BLM SCALAR FIX -Based on findbhudda's original design:
http://www.midibox.org/dokuwiki/doku.php?id=findbuddha

DESIGN FILES:
Corrected blm-scalar v1.1.brd below & attached: blm-scalar_v1.1.zip

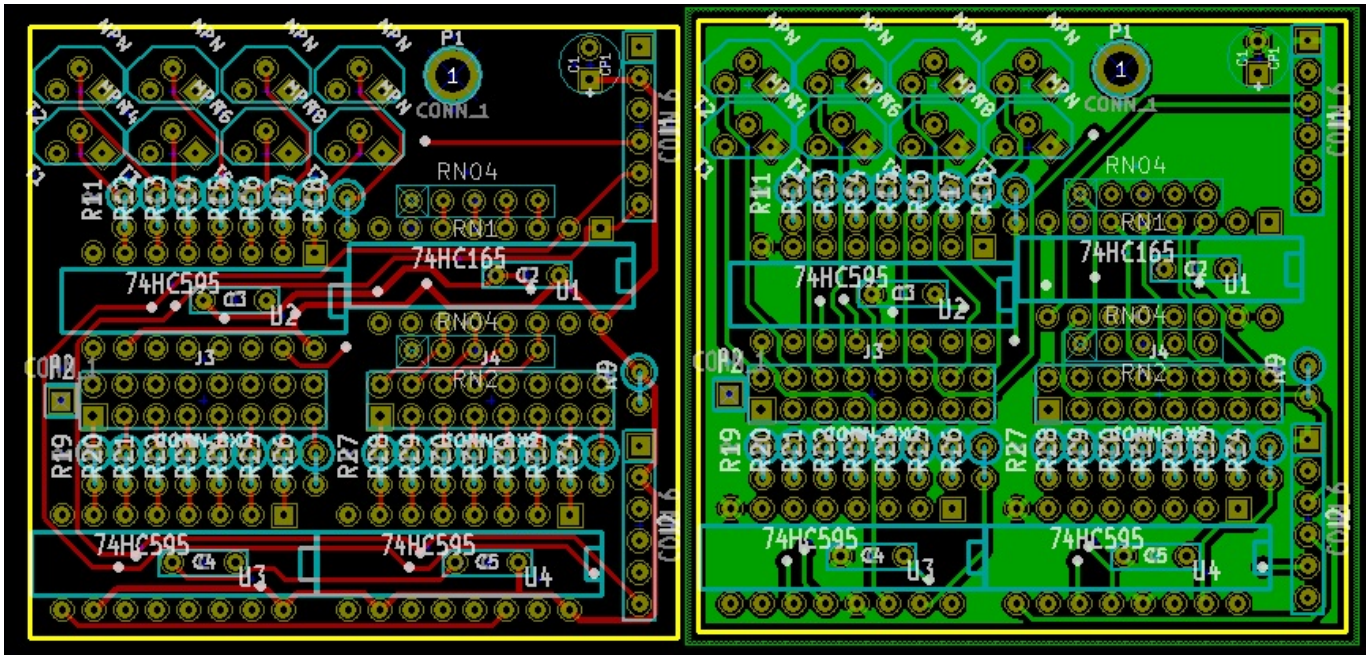
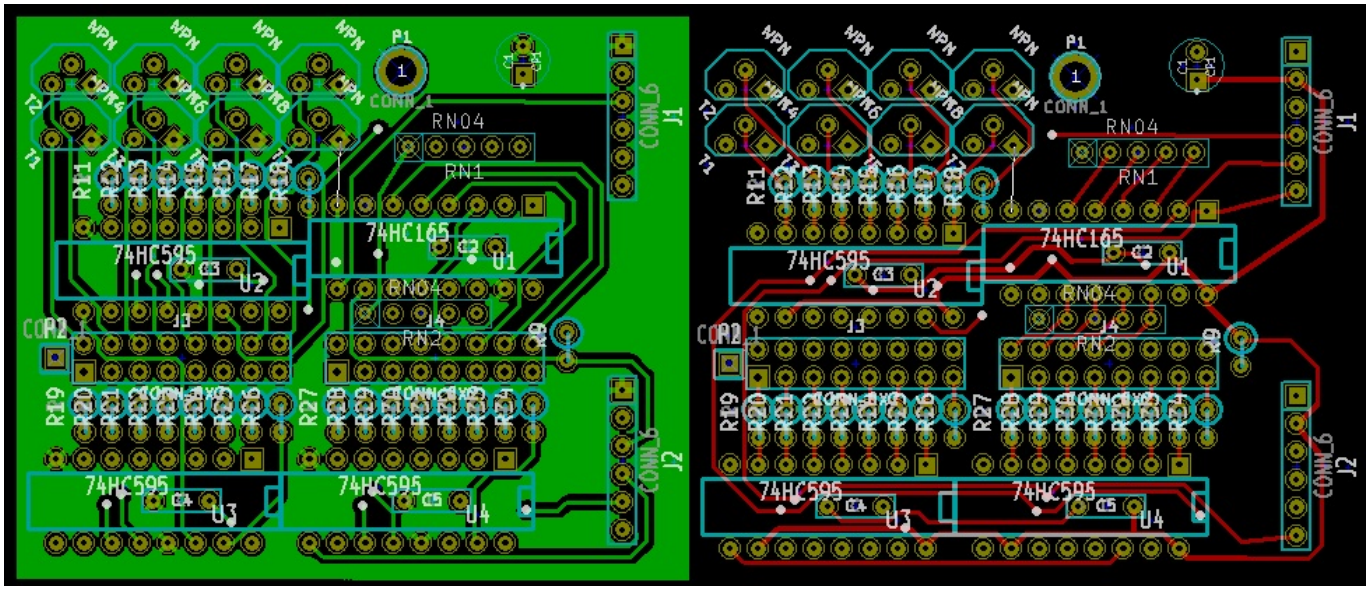
KNOWN ISSUES / BUILD SUGGESTIONS:
- blm-scalar.* contain an error. Pins I4-I7 are mirrored. This is easily fixed with a connector modification, and the blm-scalar module seems to work as intended.
- blm-scalar v1.1 attempts to fix this error. Moved connectors J1, J2, Resistor Net 1 and R9 to make room for corrections.
